Docket No. 50-277
and 50-278

The Commission has issued Amendment Nos. 63 and 62 to Facility Operating License Nos. DPR-44 and DPR-56 for the Peach Bottom Atomic Power Station Unit Nos. 2 and 3. These amendments revise the Technical Specifications and are in response to your applications dated May 8 and August 2, 1979 as supplemented by information contained in your letter dated October 2, 1979.

The amendment for Peach Bottom Unit 3 (DPR-56) involves:

The amendment for Peach Bottom Unit 2 (DPR-44) involves the reactor vessel material surveillance program and administrative changes (items 8 and 9 above).

Figure 3.4.1

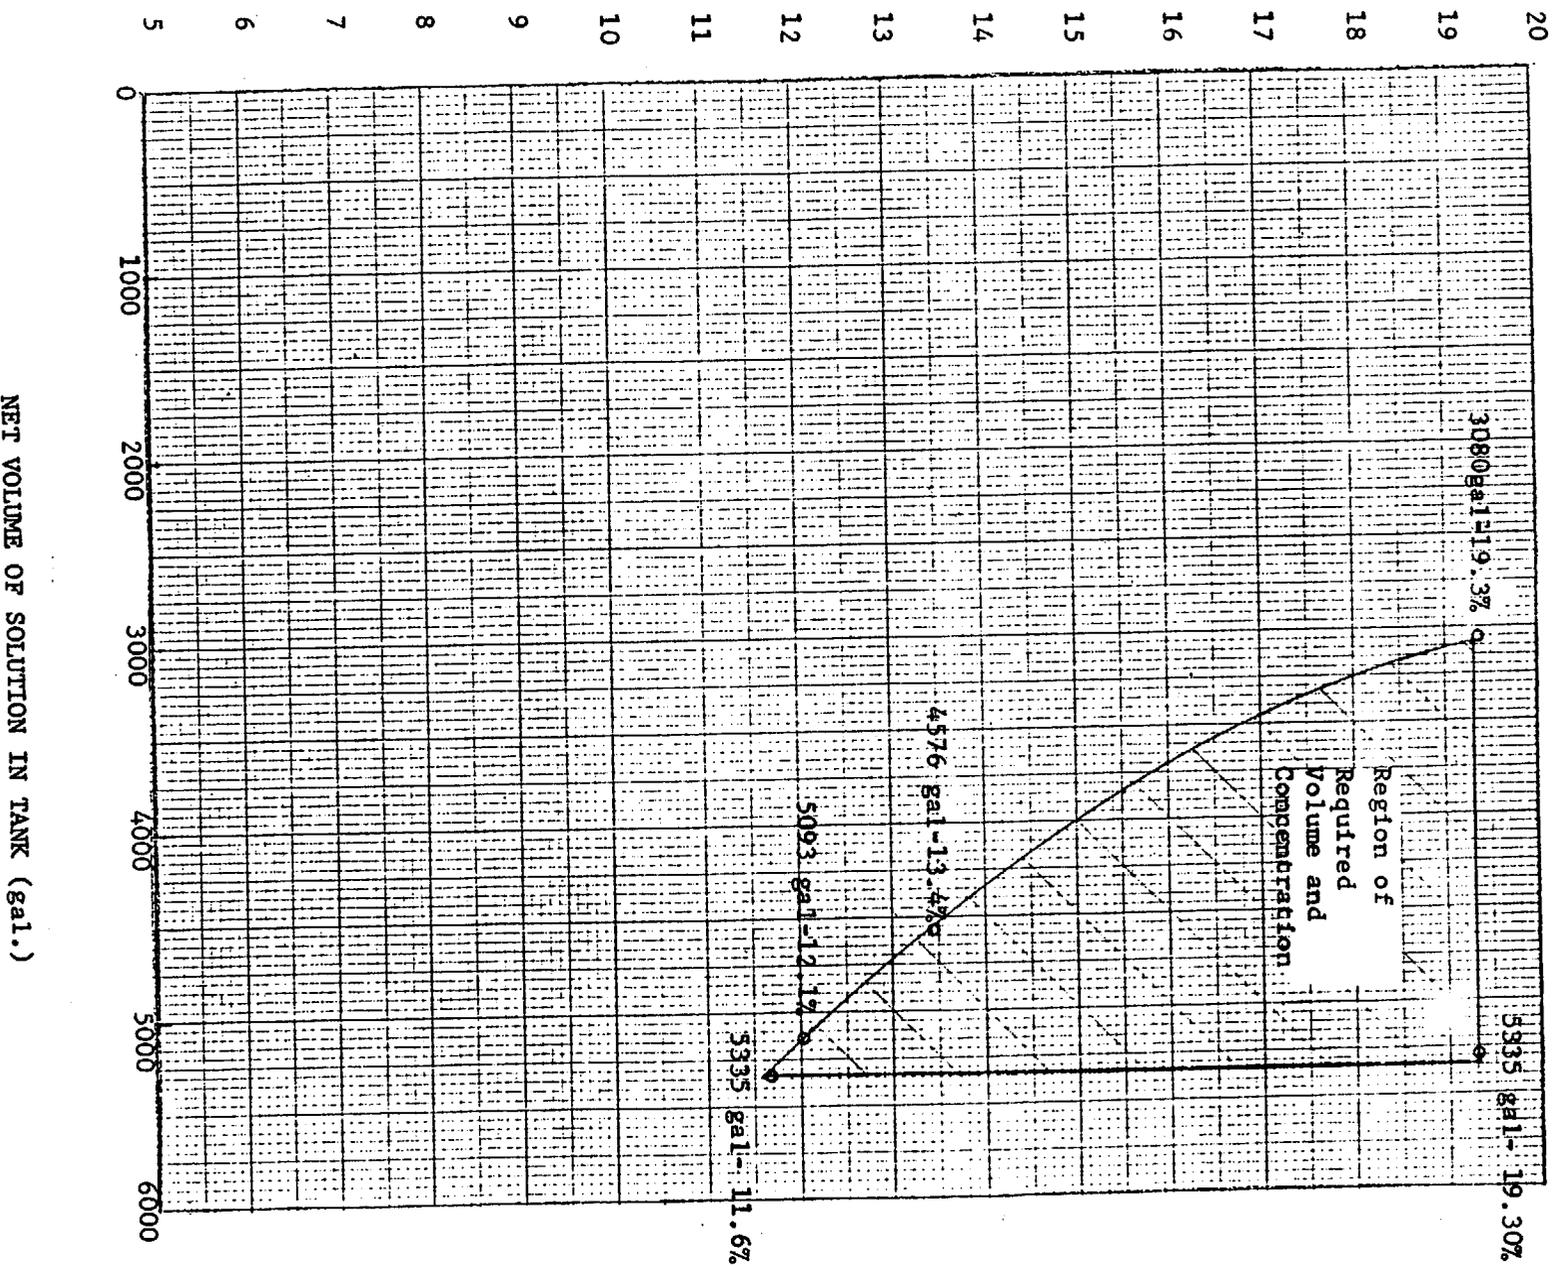
A minimum quantity of 3080 gallons of solution having a 19.3 percent sodium pentaborate concentration, or the equivalent as shown in Figure 3.4.1, is required to meet this shutdown requirement. The minimum required pumping rate of 43 gpm is based on the injection of the maximum volume permitted in Figure 3.4.1 in less than 125 minutes.

Figure 3.5.1.H Maximum Average Planar Linear Heat Generation Rate
Versus Planar Average Exposure

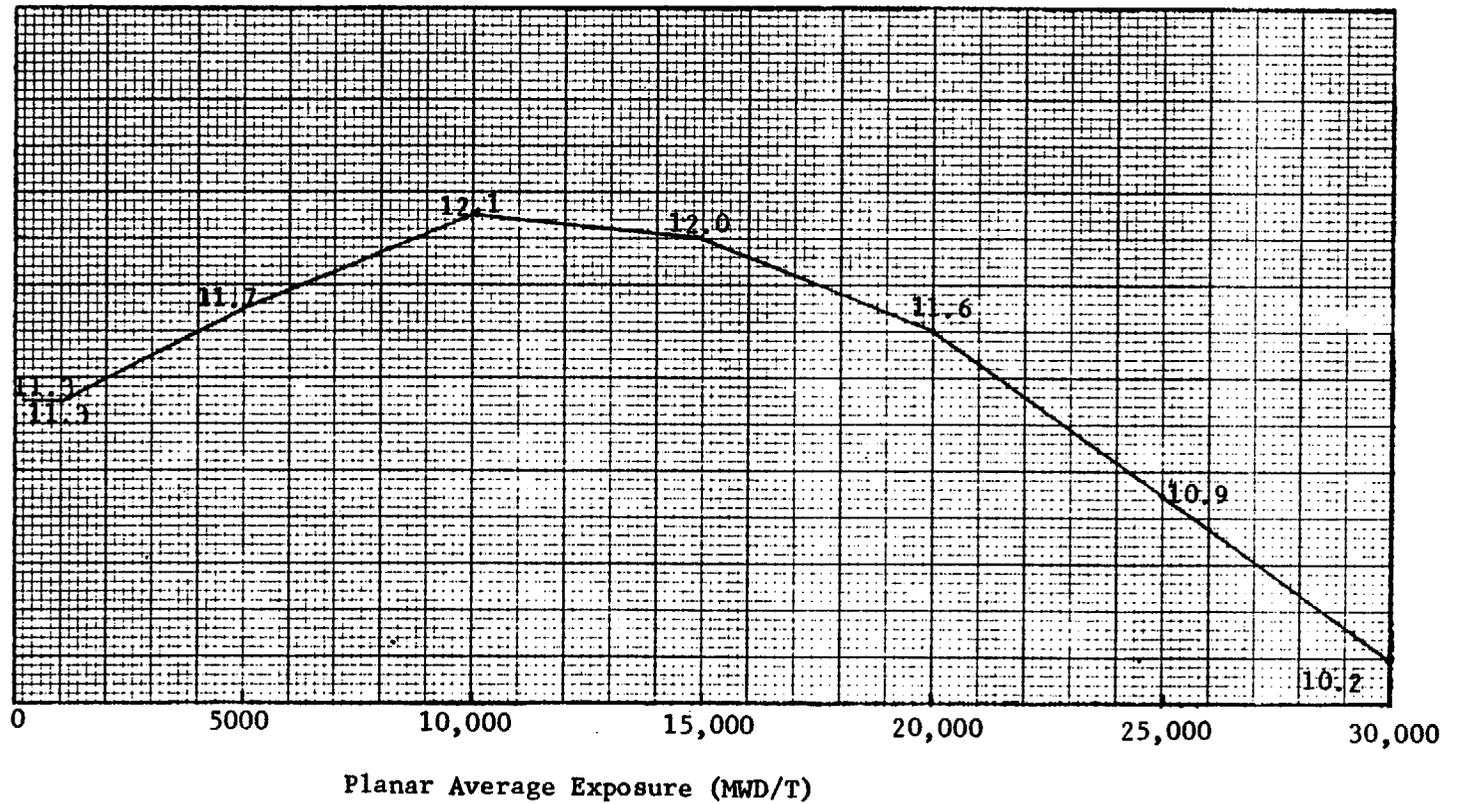
During power operation, the APLHGR for each type of fuel as a function of average planar exposure shall not exceed the limiting value shown in Figure 3.5.1.A, B, C, D, F, G & H as applicable. If at any time during operation it is determined by normal surveillance that the limiting value of APLHGR is being exceeded, action shall be initiated within one (1) hour to restore APLHGR to within prescribed limits. If the APLHGR is not returned to within prescribed limits within five (5) hours reactor power shall be decreased at a rate which would bring the reactor to the cold shutdown condition within 36 hours unless APLHGR is returned to within limits during this period. Surveillance and corresponding action shall continue until reactor operation is within the prescribed limits.

The calculational procedure used to establish the APLHGR shown on Figures 3.5.1.A, B, C, D, F, G, and H is based on a loss-of-coolant accident analysis. The analysis was performed using General Electric (GE) calculational models which are consistent with the requirements of Appendix K to 10 CFR Part 50. A complete discussion of each code employed in the analysis is presented in Reference 4. Input and model changes in the Peach Bottom loss-of-coolant analysis which are different from the previous analyses performed with Reference 4 are described in detail in Reference 8. These changes to the analysis include: (1) consideration of the counter current flow limiting (CCFL) effect, (2) corrected code inputs, and (3) the effect of drilling alternate flow paths in the bundle lower tie plate.
